DESIGN REVIEW/CERTIFICATE OF APPROPRIATENESS APPLICATION

PROPERTY INFORMATION
Project/Property Address: Sheetz Gahanna / TBD (Lot Combination in Progress)
Project Name/Business Name: Sheetz Gahanna/ Skilken Gold Real Estate Development
Parcel #: 025011244,025011243,025011226
Zoning: NC
Acreage: 4.19

June 27, 2022

RE: Sheetz Gahanna | Plan Review

**SITE PLAN**

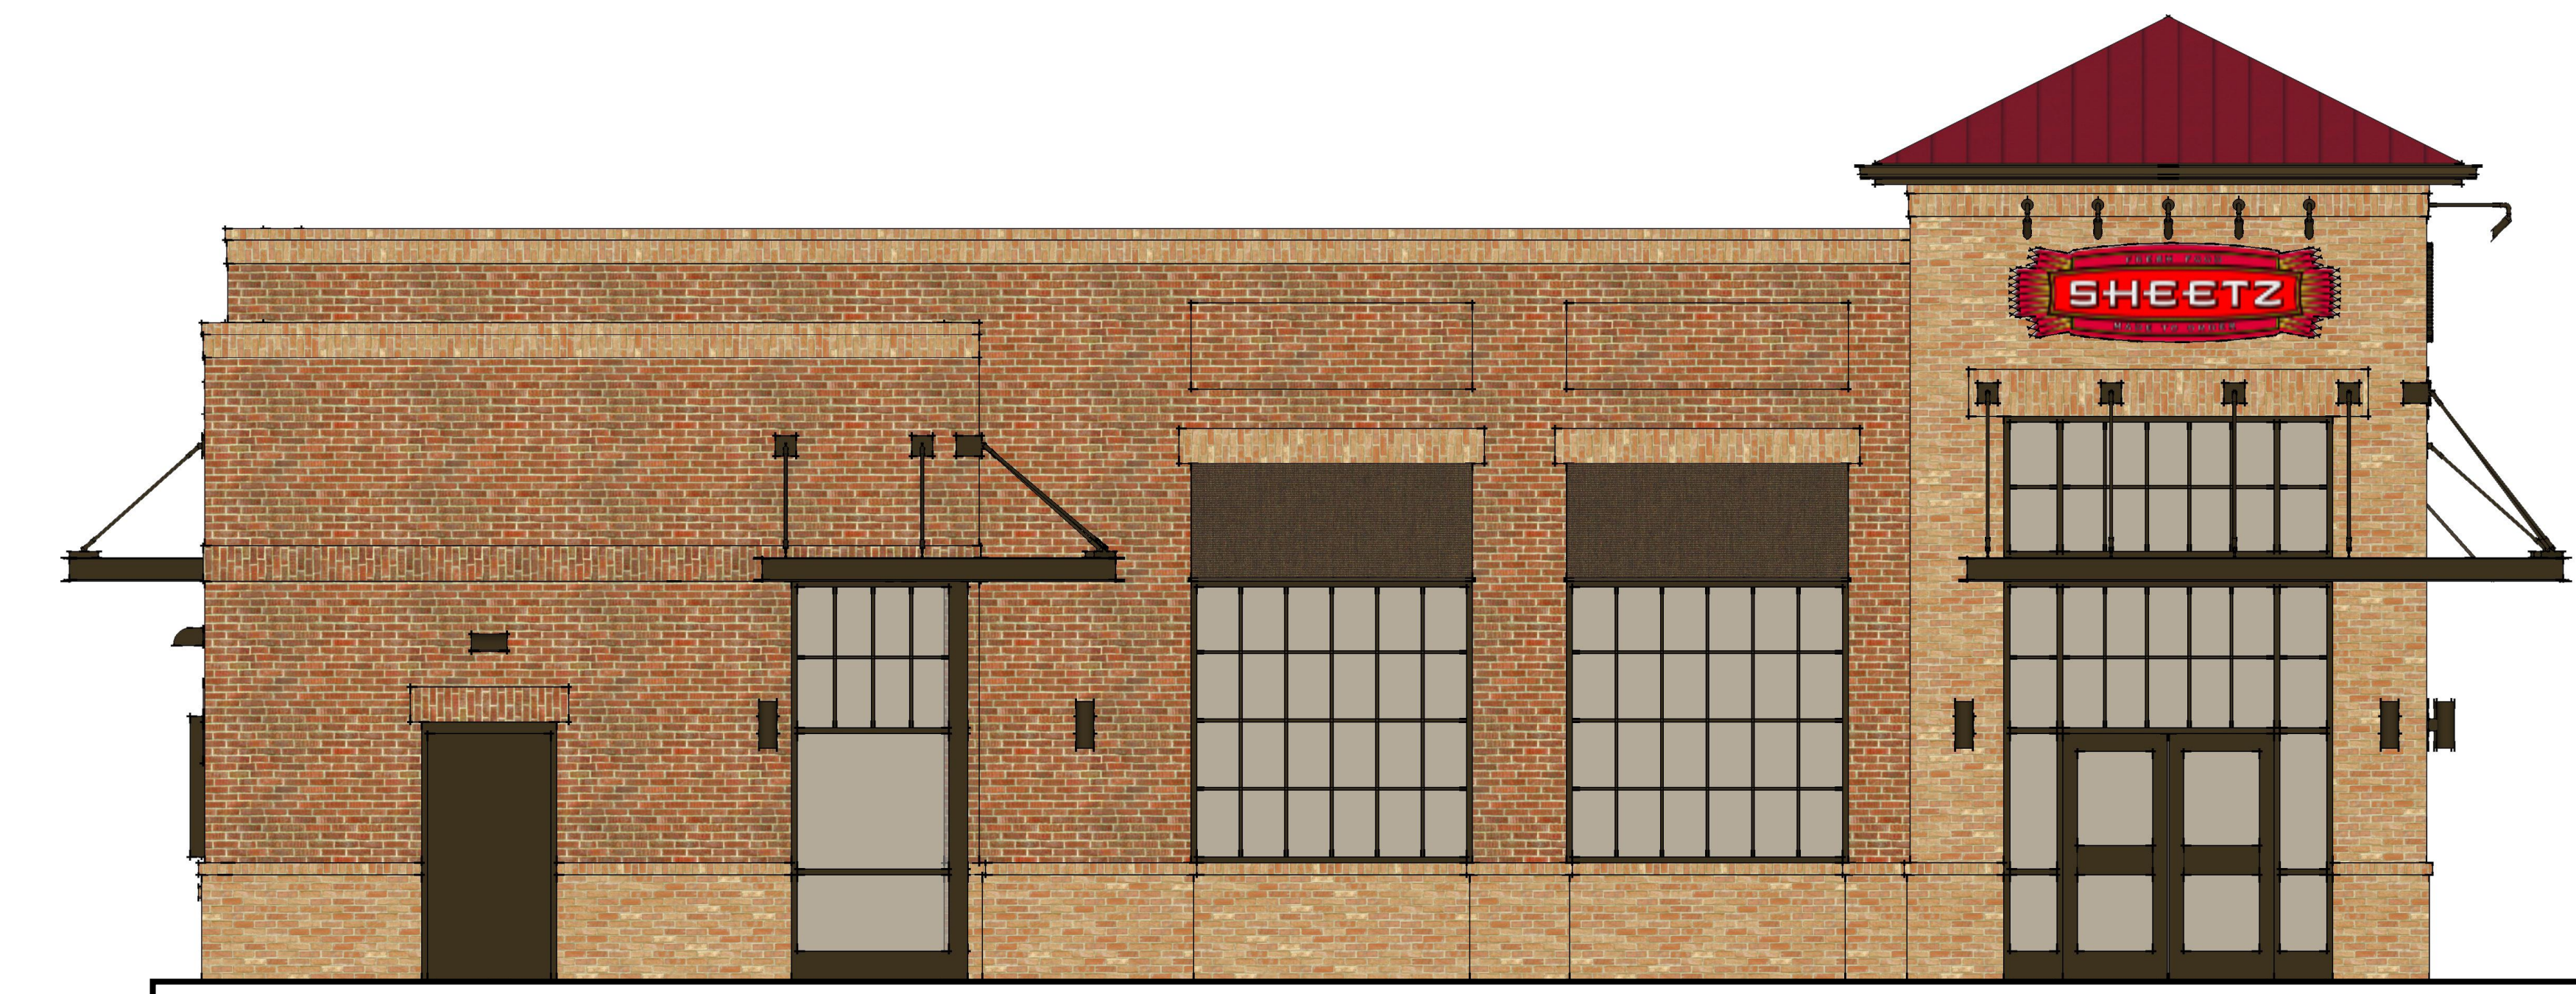
4. Minimum 15ft side yard building setback required per Section 1153.02(c)(4). Please revise the site plan.
  - [The setbacks have been adjusted to meet and address this comment.](#)

- [See cover letter for response by Skilken Gold.](#)
6. Label the height of the building.
  - [Addressed as stated on the site plan](#)
7. Access drives shall not exceed 35 feet wide per Section 1163.03(a). 36 feet is proposed.

- This will be addressed after full engineering plans start.
15. Access drives are to be a maximum of 36' wide per Gahanna Codified Ordinance 1163.03. Revise plans to show a 35' access drive.

- [Plans updated to show 35' wide access drive.](#)
8. Section 1167.18(c)(1) requires trash receptacles to be located to the rear of the main structure. A variance may be requested.

- Plans updated to show 35' wide access drive.
16. Proposed fence is shown in public right-of-way on both frontages. Please shift locations to outside right-of-way.

# TREE PRESERVATION PLAN

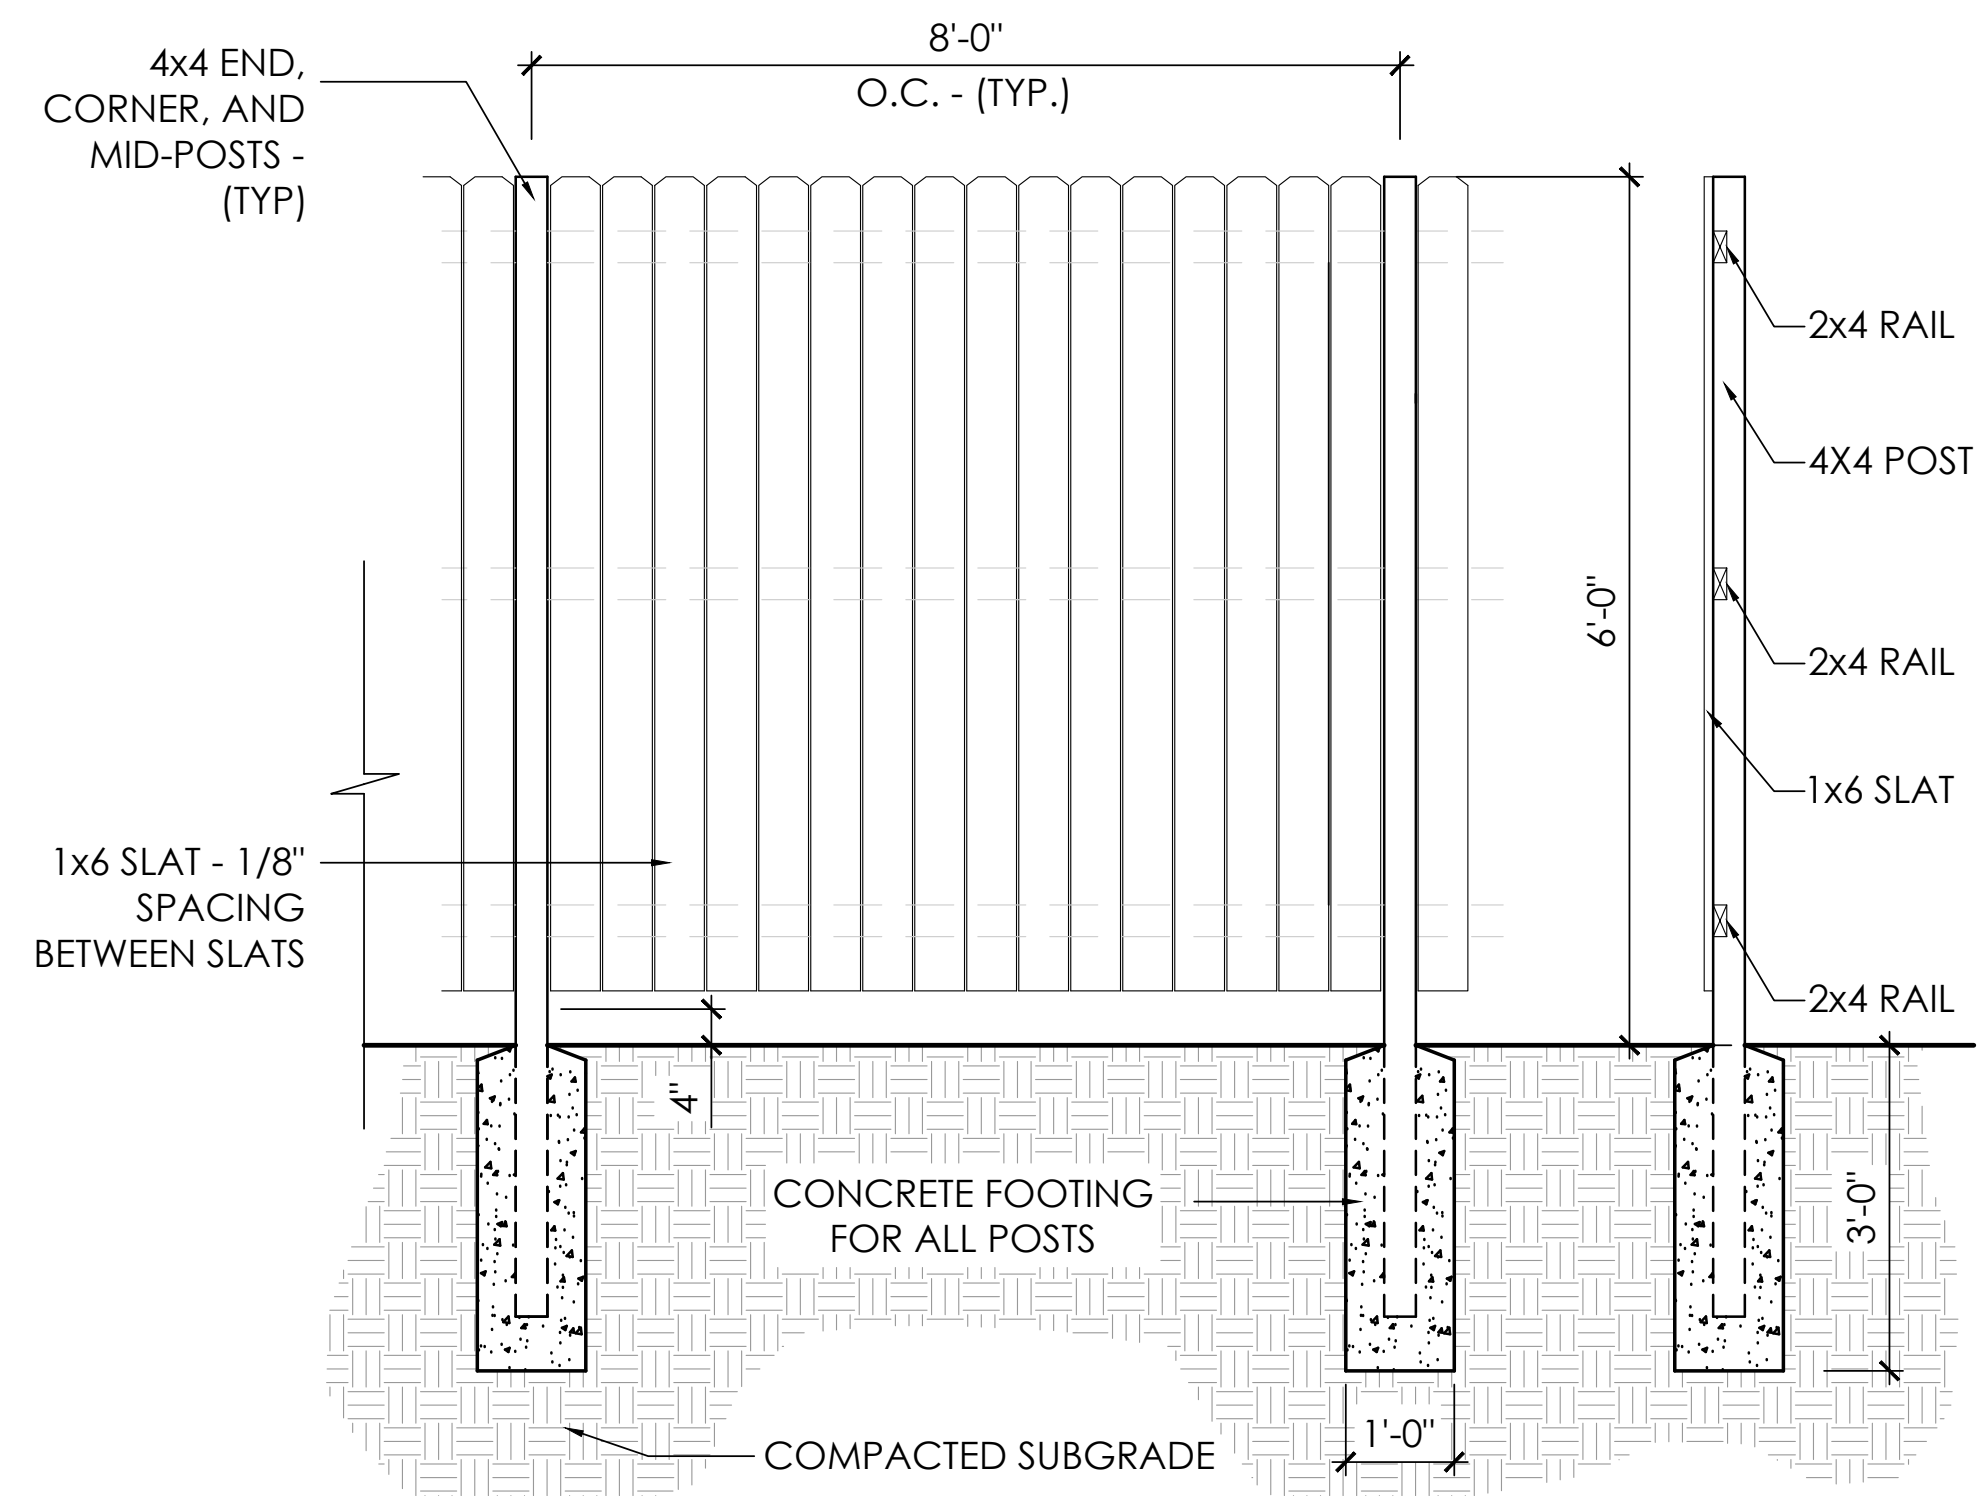
5. The species selection for new plantings looks appropriate, and I am glad to see specs for protective fencing included. I would like to see the species and condition of proposed preserved trees included in plans. Planting specifications look appropriate. I did not see a variance come through for the interior landscape requirements, but I see in the notes that a variance is to be requested for 26 trees.

***Sheet L-3 has been updated to include general identification of the existing trees on-site that are to remain. The tree to remain in the middle of the E. Johnstown Road frontage is a maple (Landscape Architect thinks it is a sugar maple), and the tree in the SE corner of the site is an Eastern Cottonwood. The trees within the public right-of-way, along the Morse Road frontage are a mix of oak, maple and sycamore trees.***
